Handling and Servicing Safety-Related **Product Bulletin**

Product Affected:

Genesys™ 3U 10kW/15kW products with rated output voltage 600V or below.
Genesys™ 2U 3.3kW/5kW products with input voltage 400VAC or 480VAC
All models of GENESYS+™ 5KW

Models with output voltage $\leq 100V$

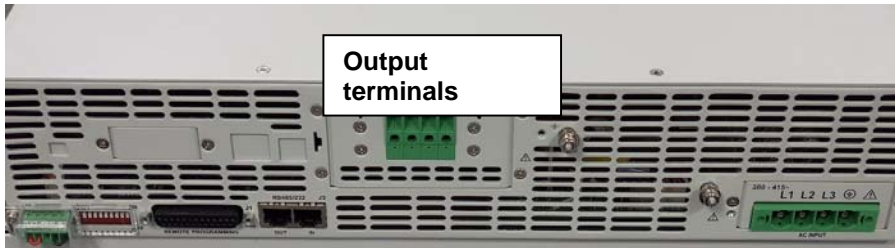
Step 3:

Connect one end to GROUND stud:

Step 4:

Connect other end to negative output terminal and hold for 2 seconds.

Step 5:

Connect other end to positive output terminal and hold for 2 seconds.
